STAFF REPORT
COMMUNITY DEVELOPMENT DEPARTMENT

HEARING DATE: May 3, 2022
 TO: Mayor & City Council
 FROM: Joseph Dodson, Associate Planner
 208-884-5533
 SUBJECT: H-2022-0005
 Summertown Subdivision

LOCATION: Site is located at 3104 N. Venable, at the southeast corner of N. Venable Lane and W. Ustick Road, In the NW 1/4 of the NE 1/4 of Section 1, Township 3N, Range 1 W.

B. Preliminary Plat (dated: January 2022)

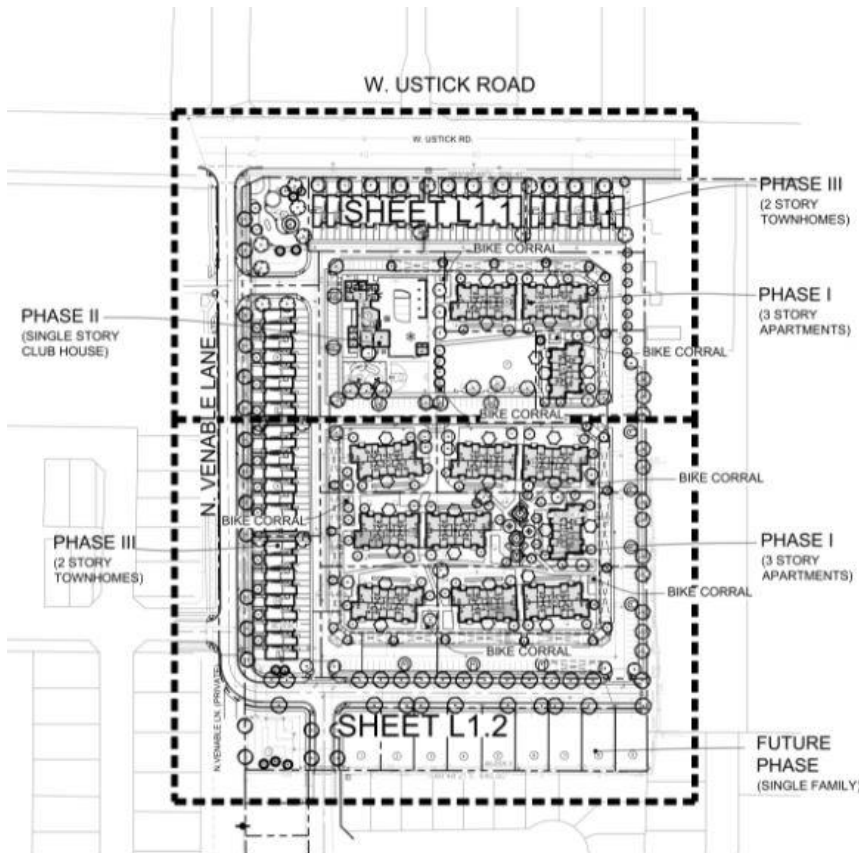
Upon analysis of the submitted plat, it appears N. Venable Lane is being shown as a 29-foot collector street section for its entire length, from Ustick south to Wrangler Street connection point at the southwest corner of the project. Previous approvals allow Venable to be constructed with this reduced collector street section for a majority of its length but not in its entirety. According to ACHD, Venable should be constructed as 36-foot wide collector street section from Ustick and 245 feet south to the northern drive aisle connection across from the existing drive aisle connection to Venable for the Crossfield Apartments. It is unclear on the submitted plat if this condition of approval is being shown accurately. The Applicant should revise the plat to meet this condition of approval or provide written documentation that ACHD has approved a reduced street section for this area of the project.

8-foot wide parkways with street trees are shown along both sides of the proposed local streets (W. Wrangler and N. Ridgebury). **All parkways within the site adjacent to detached sidewalks shall be landscaped per the standards listed in UDC 11-3B-7C.** According to the submitted landscape plan, there appears to be the correct number of trees but the table does not accurately describe the parkway along W. Wrangler and instead labels it as perimeter landscaping. With the future final plat application,

the Applicant should correct this and list this parkway within the landscape table and show the correct number trees.

Staff notes the existing approvals do not account for the parkways along W. Wrangler and the Ridgebury Avenue stub. So, the amount of qualified open space is in fact higher than previously noted—with the final plat submittal, the applicant should revise the open space calculations and include these parkways.

11. The submitted preliminary plat, dated January 2022, shall be revised as follows prior to Final Plat submittal:
 - a. Depict the required landscape buffers along Ustick and Venable via a landscape easement—ensure minimum width of 25 feet along Ustick is noted despite not being on property (measured from back of curb).

- b. Add a plat note referencing the required license agreement with ACHD for the portion of the landscape buffer in the public right-of-way, per UDC 11-3B-7C.5.b.

- c. Construct a 10-foot wide multi-use pathway on the east side of N. Venable Lane. ~~and within Lot 1, Block 2 consistent with the Pathways Master Plan.~~

- d. Remove the sidewalk on the west side of N. Ridgebury Lane (east side of Lots 8, 9, & 14, Block 1) to move the units east to accommodate the multi-use pathway on the east side of N. Venable.

- e. Depict the private streets within a singular common lot or clearly depict the private street easement on the plat, in accord with UDC 11-3F-4A.
 - f. Add a plat note stating “No direct lot access is permitted to W. Ustick Road or N. Venable Lane.”
12. The submitted landscape plan, dated December 27, 2021, shall be revised prior to final plat submittal:
- a. Revise the landscape plans consistent with the preliminary plat revisions noted above in condition VIII.A.8.
 - b. Add data to the landscape plans showing compliance with UDC 11-3B-7C for the proposed parkways.
 - c. Clearly depict the required street buffers along W. Ustick Road and N. Venable Lane.
